Supplement

Title: 712 Inst.Sht. Supplement Issue: **6**
Part Number: 650280 Issue Date: 2/11
Print Date: August 1997 Page Count: 5
Revision/Date: 2, 5/04

Change #1, 47807

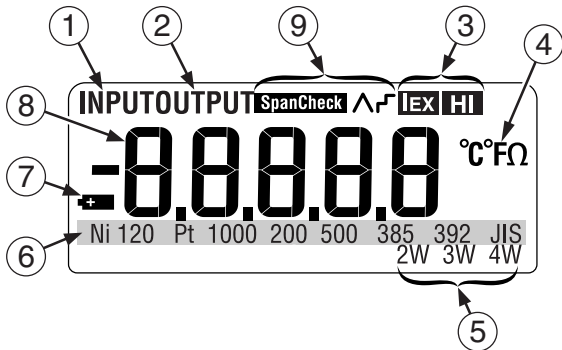
Under **Getting Acquainted with the Calibrator**, replace the figure with the following:

Under **Display Elements**, add the following to the table:

⑨ Span Check Step and Ramp	Lit when in Span Check, step and ramp modes
----------------------------	---
